**TOWN OF BAY HARBOR ISLANDS
MORRIS N. BROAD COMMUNITY CENTER
1175 95TH STREET
BAY HARBOR ISLANDS, FL 33154**

DEVELOPMENT & REVIEW COMMITTEE MEETING

ITEM: Review and discussion of the Site Plan Application by Arman Corp., to construct a new 6-unit Townhouse Development to be located at 1085 94 Street. Enclosed are the Site Plans and the Staff Report prepared by Town Planner Michael Miller.

Subject: Site Development Plan Application (3rd DRC Review)
1085 Townhouses – 6 DU Townhouse Complex
1085 94th Street
Bay Harbor Islands Acct. No. SPR24-000025
MMPA Account No. 01-0702-1197

SITE PLAN,
SITE DATA &
LOCATION PLAN

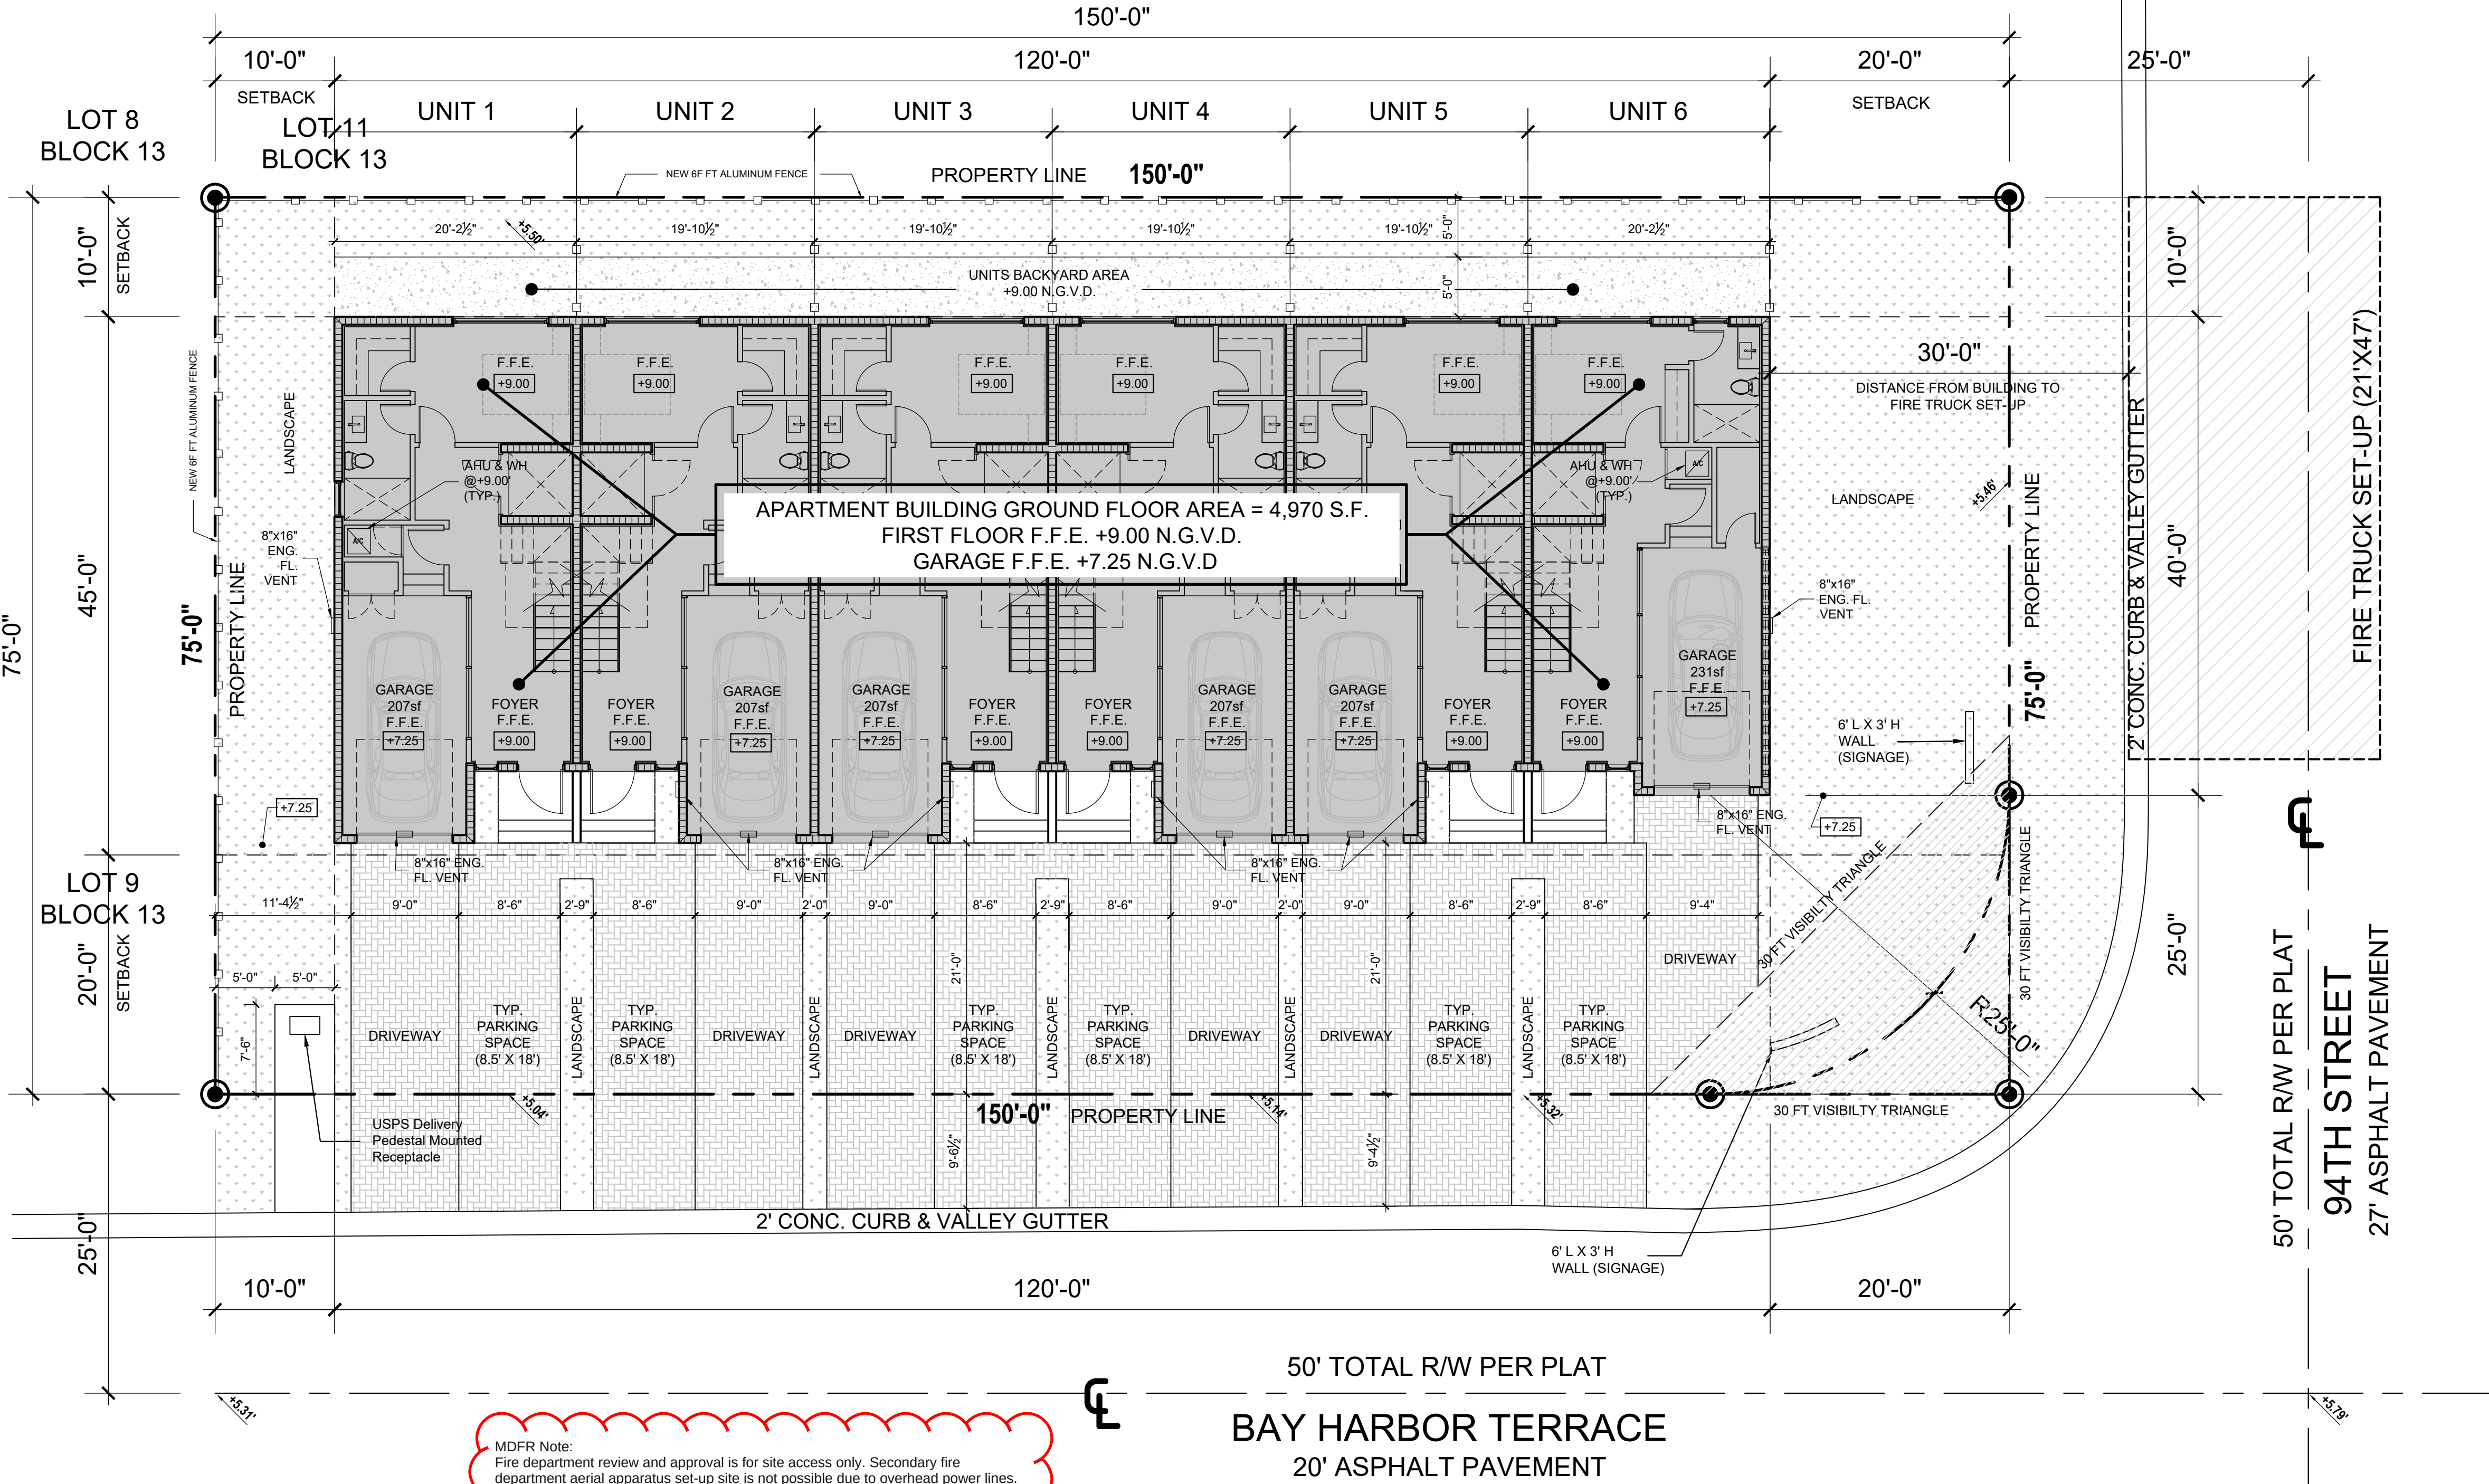
- 1) Again, Site Plan Sheet A-1 / Elevation Sheet A-3 / others do not scale to 1/8" = 1'-0". Please check and revise to provide an accurate scale. This makes it very difficult to measure / review the plans. This comment was made previously by MMPA. The applicant's response is it was corrected – but it has NOT been corrected.

- 3) Site Plan A-1 still has the following issues:
 - a. Again, per Sec. 23-24(d)(6)(b) not more than 50% of a property's street frontage in a townhouse development may have hard driveway surfaces. MMPA mentioned this at the #2 DRC meeting and requested the plans be revised to meet this Code requirement and to provide calculations demonstrating compliance. No calculations have been provided, and it appears the applicant is proposing to use so-called "pervious pavers" to achieve this requirement, but the Code prohibits that. MMPA roughly calculates that about 68.5% of the yard area facing BHT is impervious / not landscaped open space. This is not just about drainage – it is about appearance – the Town wants its streetscapes to have an open / landscaped look – not hardscapes. The project fails to meet the Code criteria. Revise. Perhaps reorient the unit along 94th Street to have its garage facing that roadway.

- b. The proposed driveway design for the DU adjoining 94th Street, in an attempt to comply with the Town's 30' visibility setback at corners, is inconsistent from sheet to sheet (Sheet A-2 appears to show it encroaching).
 - c. The Site Data Table must include the required / provided rooftop landscaped open space calculations in addition to being on new Sheet A-2d. Add below 20% data.
 - d. The Zoning Code requires that a minimum of 20% of the site be landscaped open space. The plans indicate that a minimum of 2,804 sq. ft. is required but 3,100 sq. ft. is to be provided. Please verify that the landscaped open space to be provided does not include the driveways or any other impervious area (USPS concrete pad / walks / etc.). Revise the plans as necessary to meet Code.
- 4) Provide a written response to each comment.

1. SHOW A COMPLETE FLOOD LEGEND (FINISHED FLOOR ELEVATION, LOWEST ELEVATION OF EQUIPMENT, FLOOD ZONE, PANEL NUMBER, BASE FLOOD ELEVATION, HIGHEST CROWN OF ROAD, LOWEST AND HIGHEST ADJACENT GRADE, ETC)AS PER FBC 107.3.5.

2. PLANS SHOW ENCLOSURES ON GROUND FLOOR THAT ARE BELOW DFE (BFE PLUS 1FT). CLARIFY HOW EACH OF THESE AREAS WOULD COMPLY WITH ASCE 24 (DRY OR WET FLOODPROOFING? MATERIALS BELOW BFE).

3. SHOW ALL PROPOSED ELEVATIONS (INCLUDING FINISHED FLOOR AND EQUIPMENT SERVICING THE BUILDING, GARAGE FFE, ETC), SHALL COMPLY WITH THE REQUIREMENTS IN ASCE 24, FEMAAND FBC.

Complete flood legend added to Sheet A-1.00

Proposing engineered flood vents for garage areas below flood. See Site plan and flood legend sheet A-1.00

Showing finished floor heights (FFE) and mounting height of equipment. See flood legend and Site plan on Sheet A-1.00

ROOF PLAN

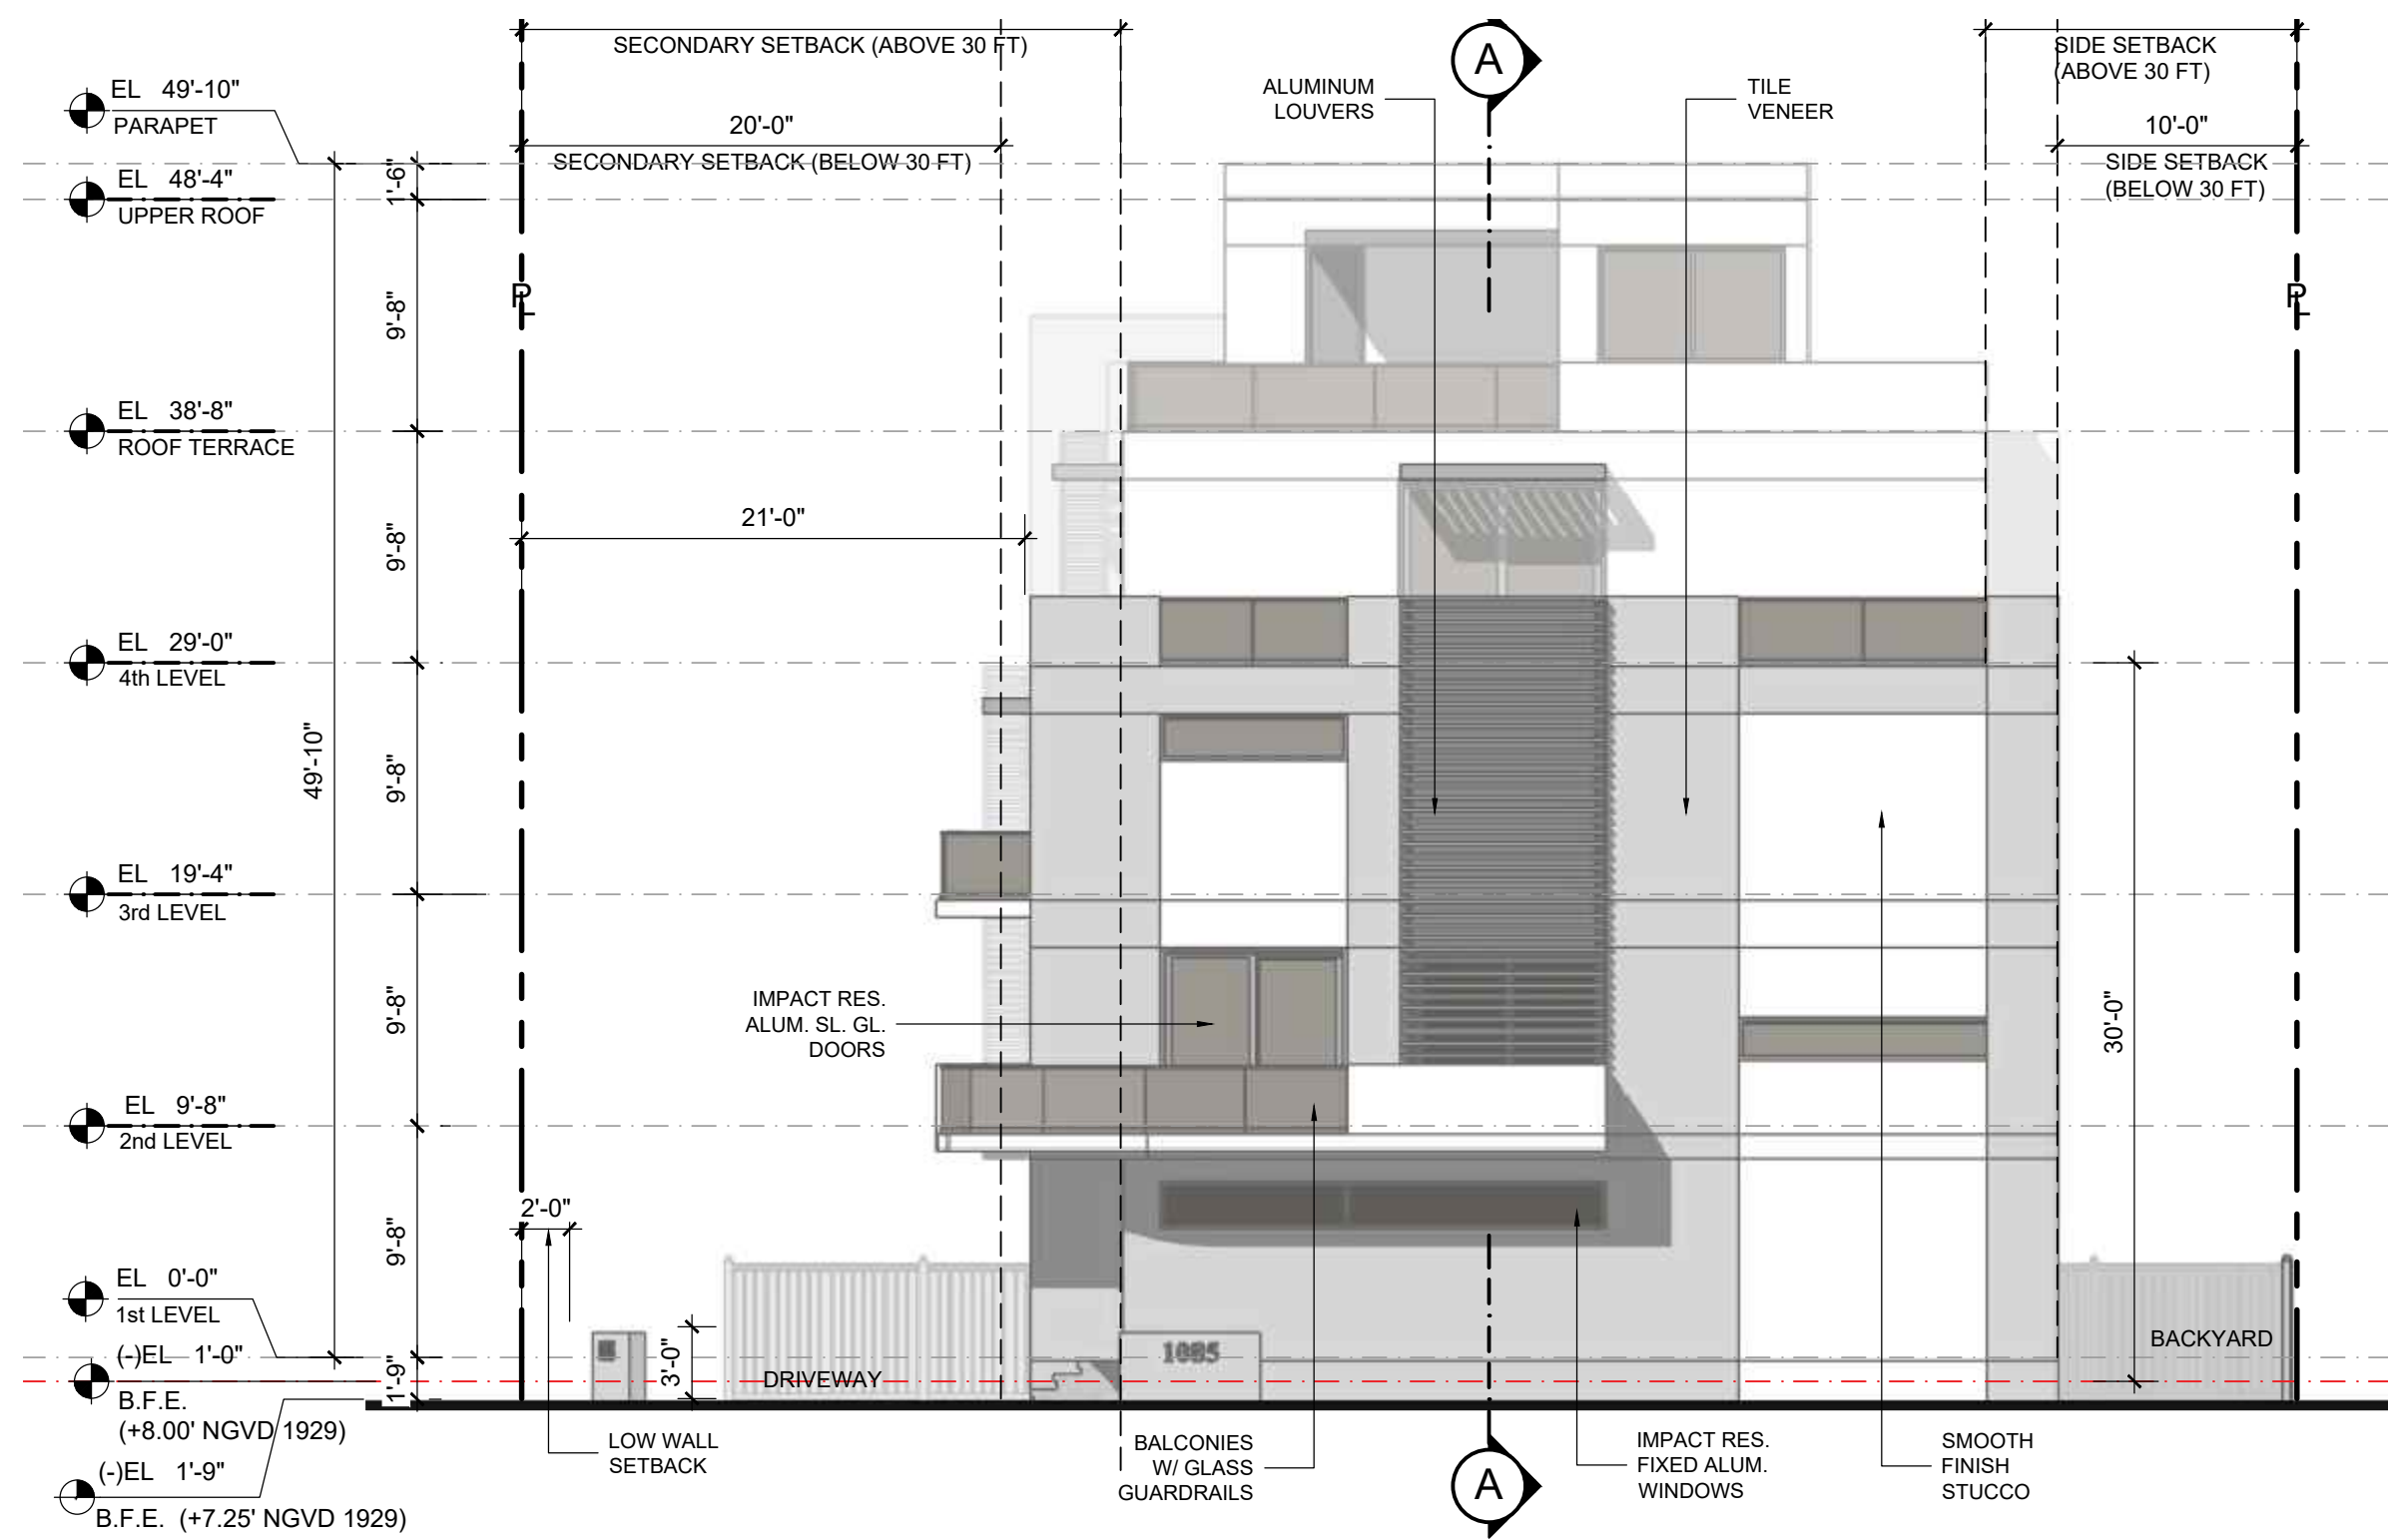
4) As noted above the rooftop areas show undefined "open roof" areas. Rooftop recreation areas must have at least 15% of the areas used for recreation landscaped. Clarify the intended use of the rooftop areas. Revise the plans to add landscaping to the roof and add this calculation to the Landscape Requirements table as well as the roof plan.

New rooftop area and landscape calculations provided as requested. Please refer to sheet A-2d
